ADDENDUM NO. 1

CUBA MUNICIPAL AIRPORT
Construct T-Hangar Building
MoDOT Project No. 25-059A-1

ADDENDUM NO. 1

**CUBA MUNICIPAL AIRPORT
Construct T-Hangar Building
MoDOT Project No. 25-059A-1**

**PROPOSED HANGAR
ELEVATIONS**

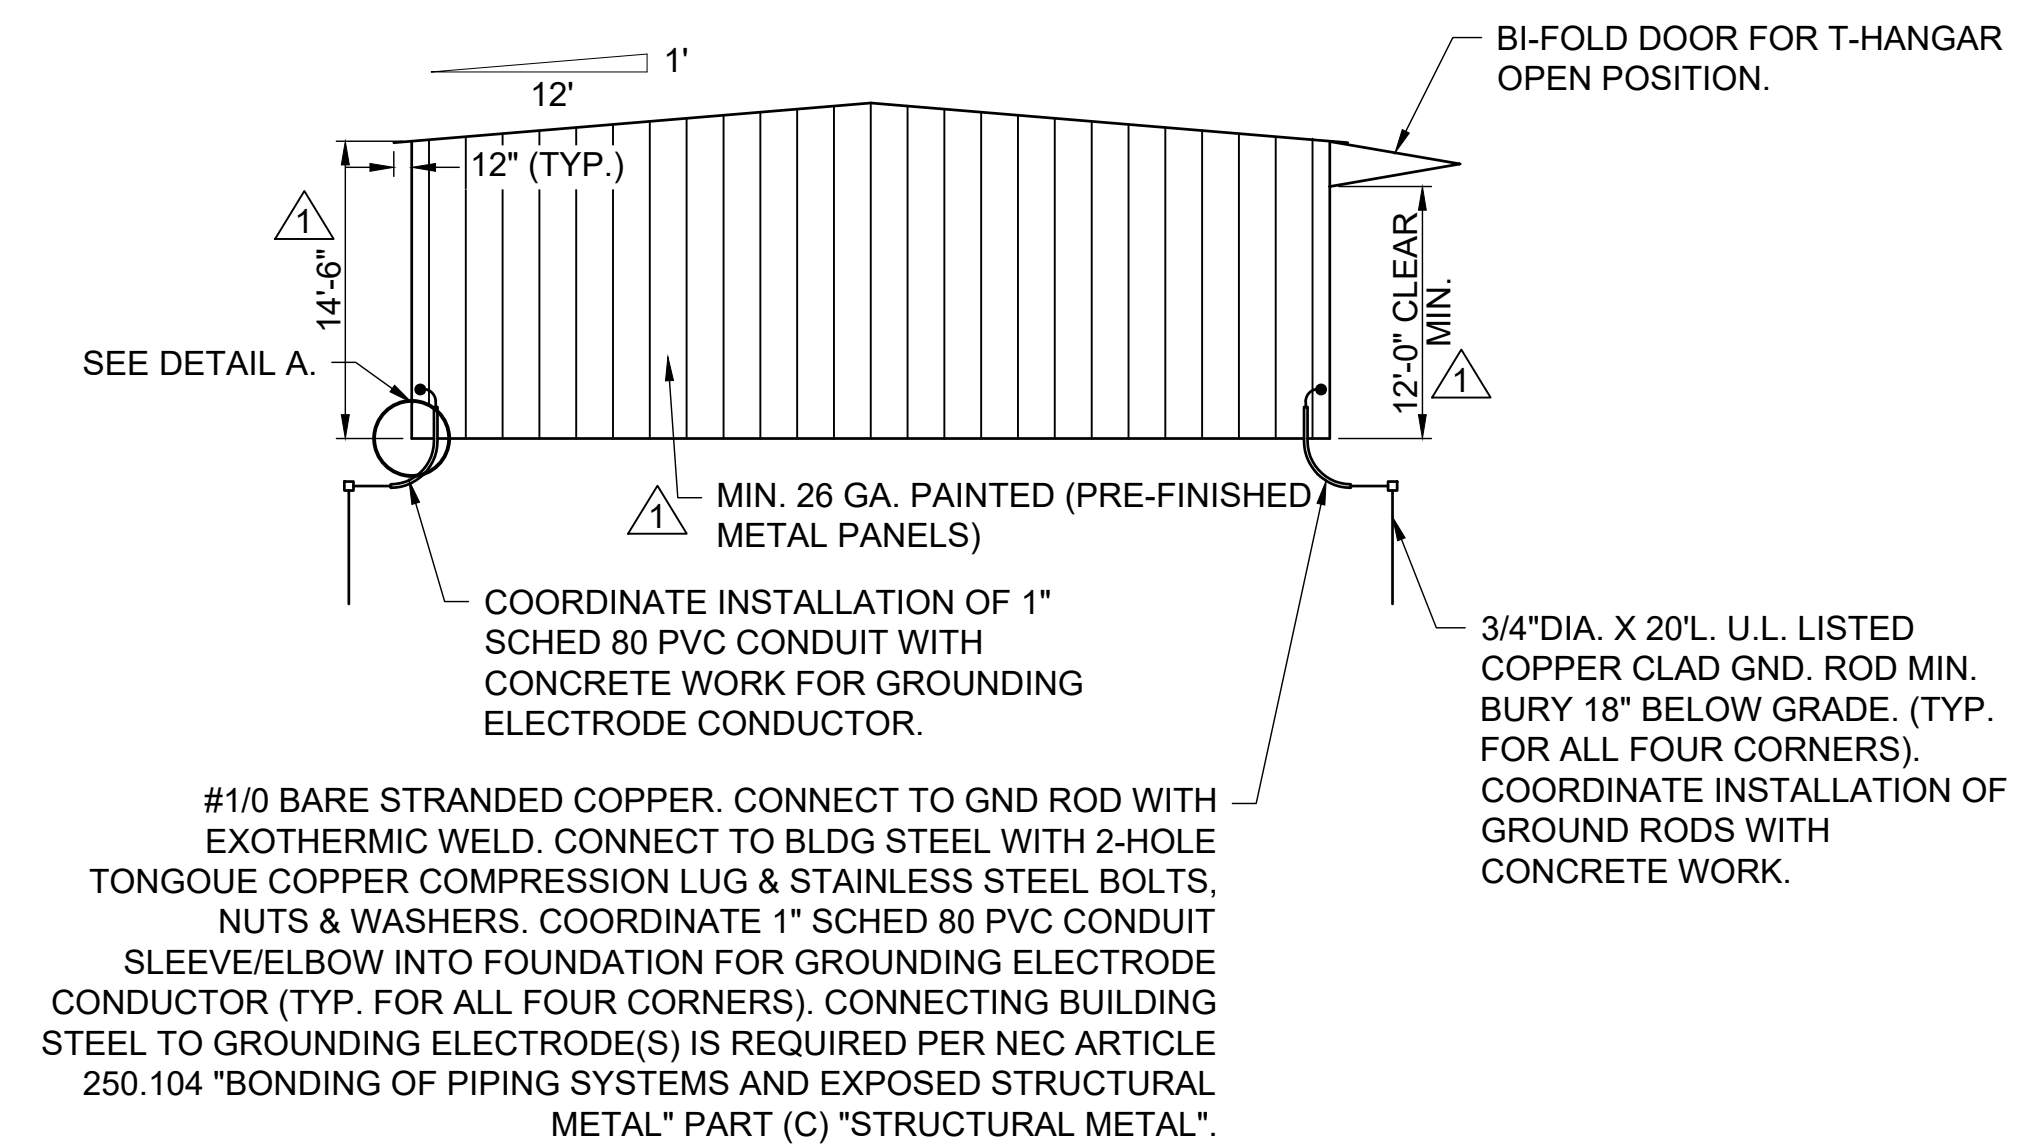
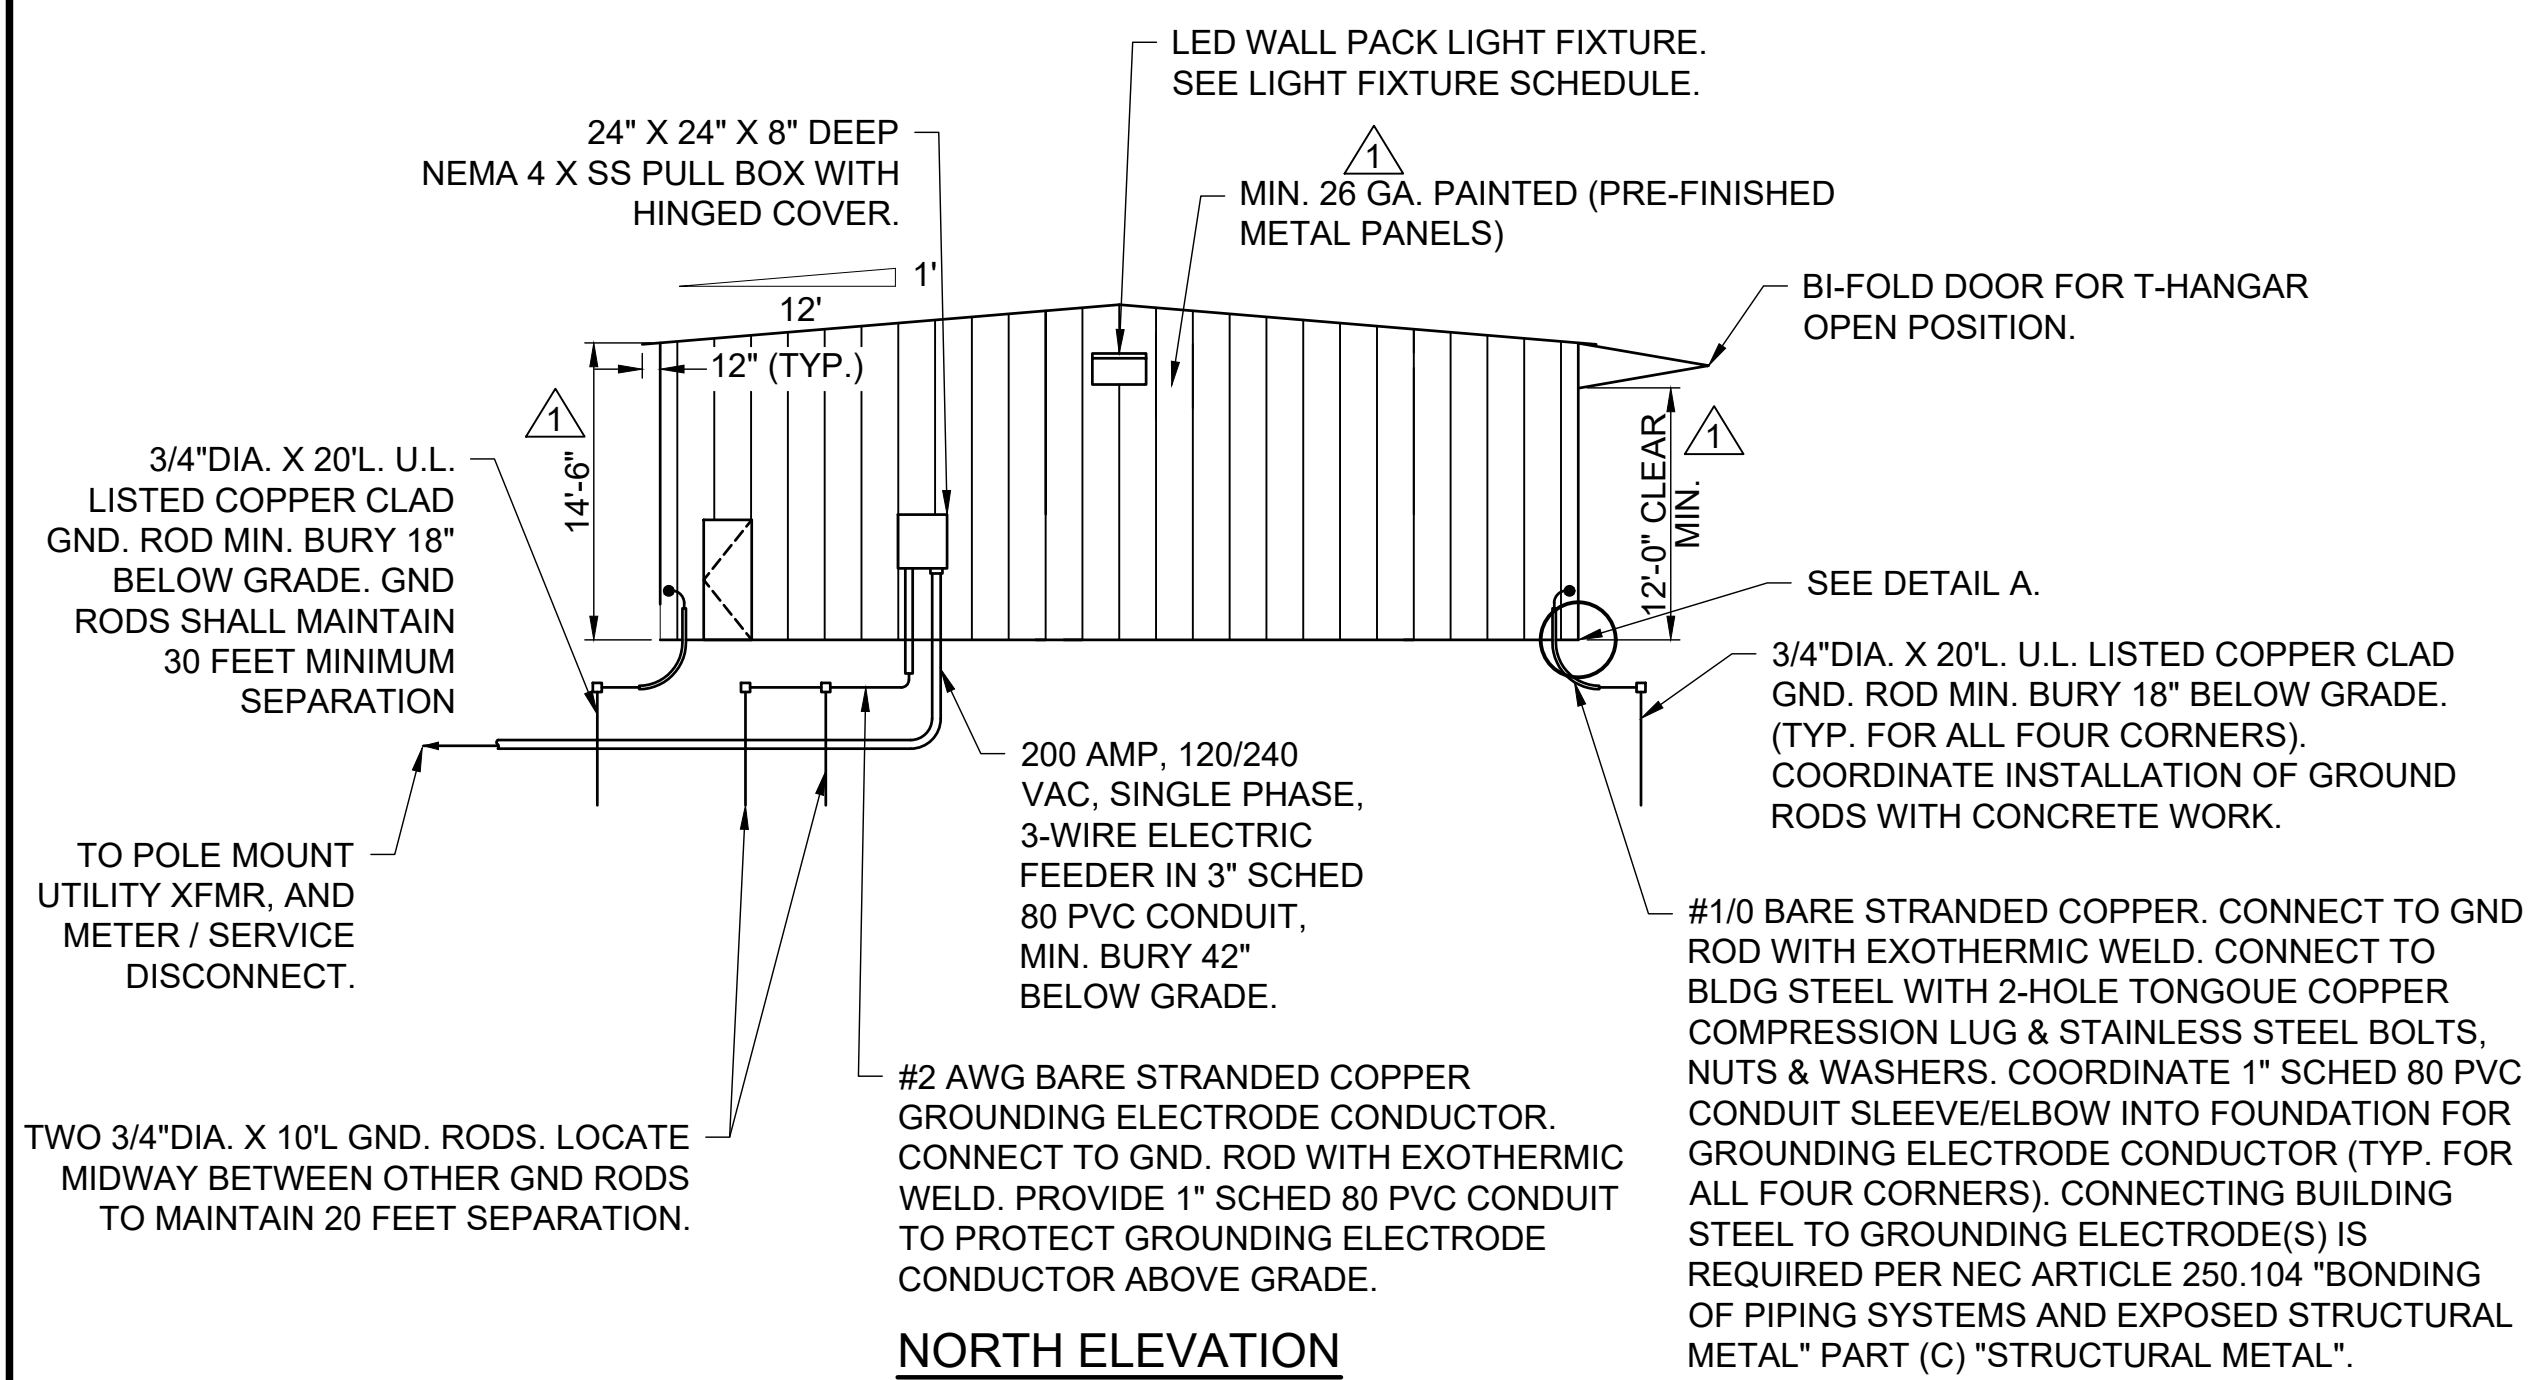
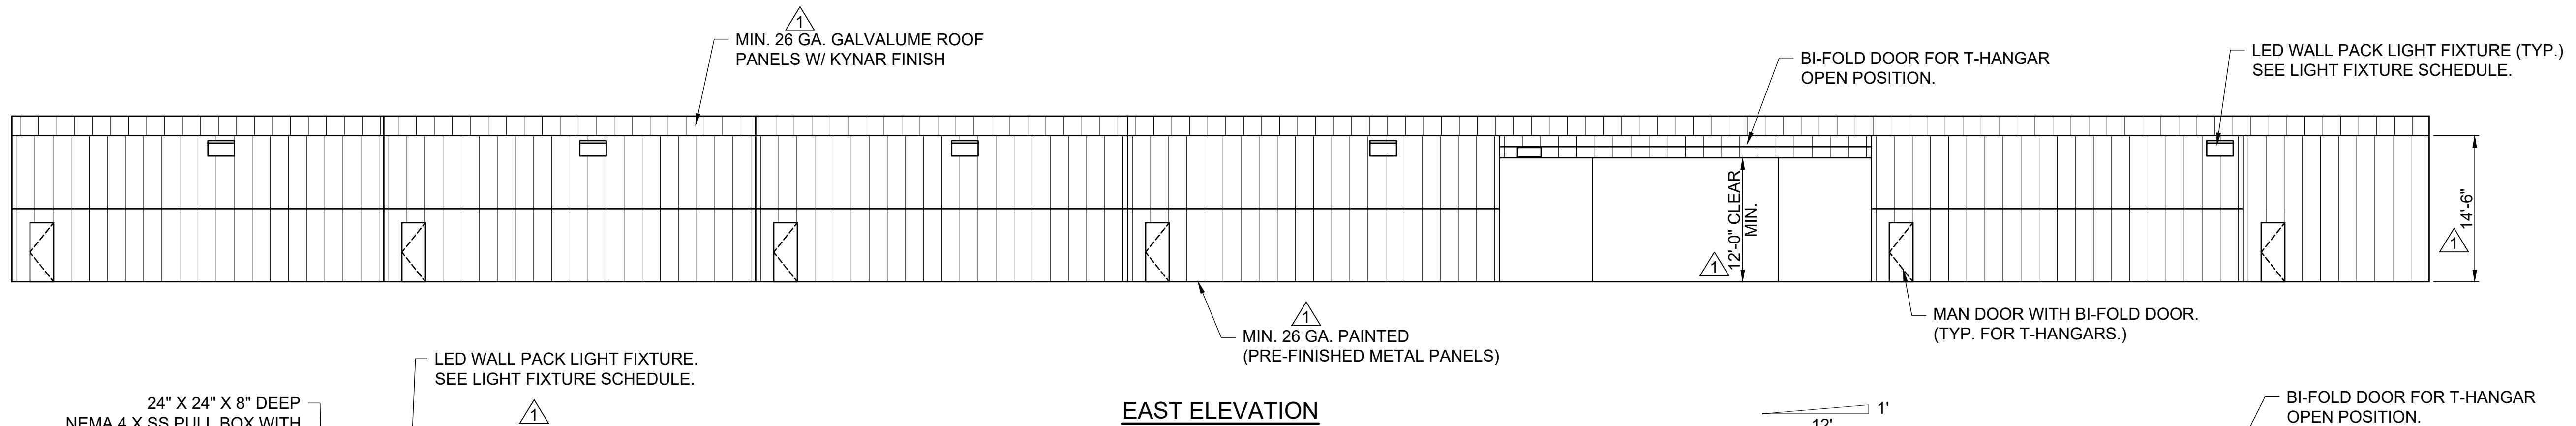
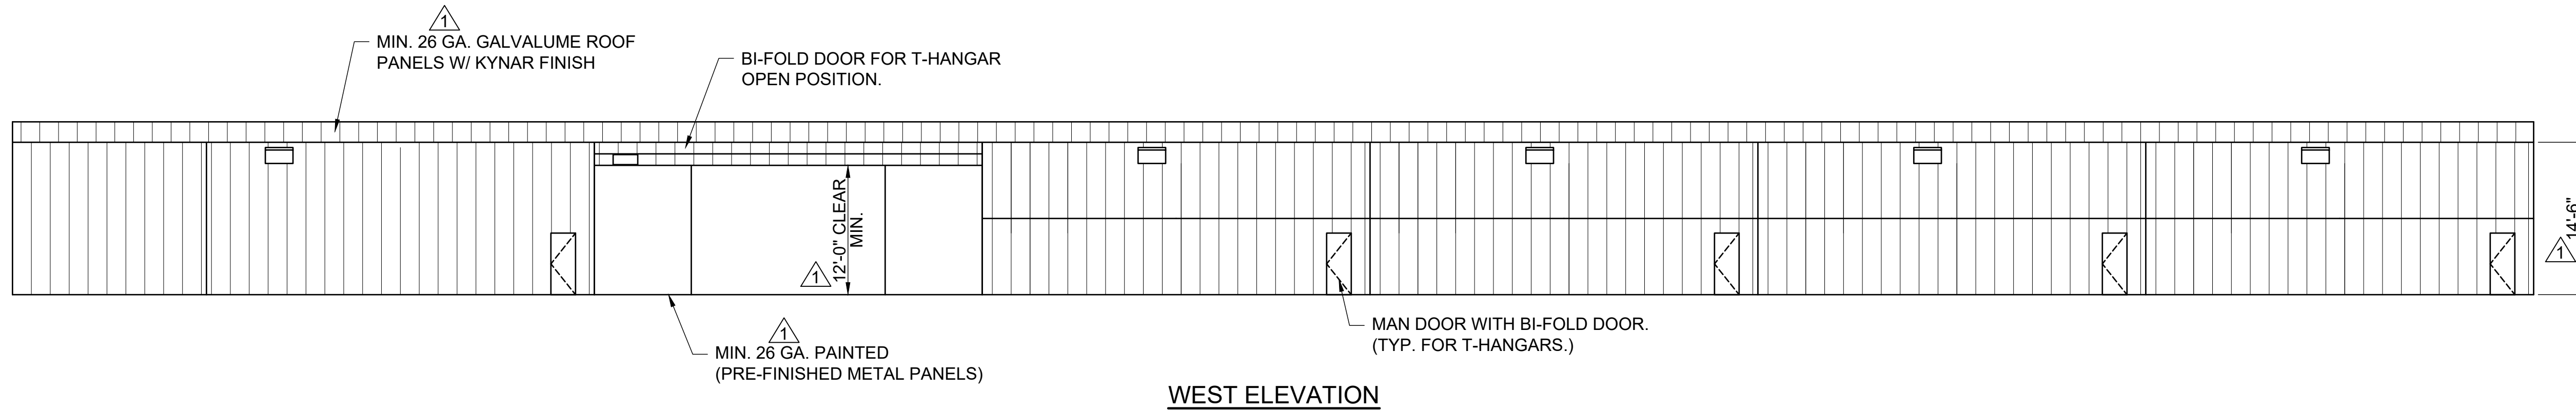
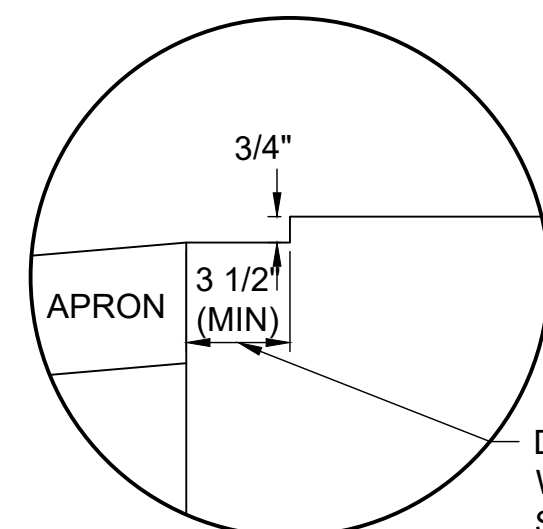
Revise: Bi-fold door overall heights are revised to **14'-6"**.
Open bi-fold door clear heights are revised to **12'-0" Min.**

Revise: All references to "MIN. 24 GA." metal panels are revised to "**MIN. 26 GA.**"

- A6:** Refer to Item 2 – Plan Sheets, Plan Sheet No. 15, of this Addendum.
- Q7:** Drawing #16 show the 42' bifold doors as having a 14'-0" clear height. Hangars with 42' wide door normally have a 12' clear height due to the class of aircraft being stored. What is the bifold door clear height required for the project?

- A7:** Refer to Item 2 – Plan Sheets, Plan Sheet No. 16, of this Addendum.
- Q8:** Note 30 on drawing #17 indicated R19 roof insulation. Insulation thicker than 4" (R13) is not recommended since the screws tend to pull through the panel when the insulation is that thick. Can the roof insulation be changed to 4" thick since it is likely only to prevent condensation?
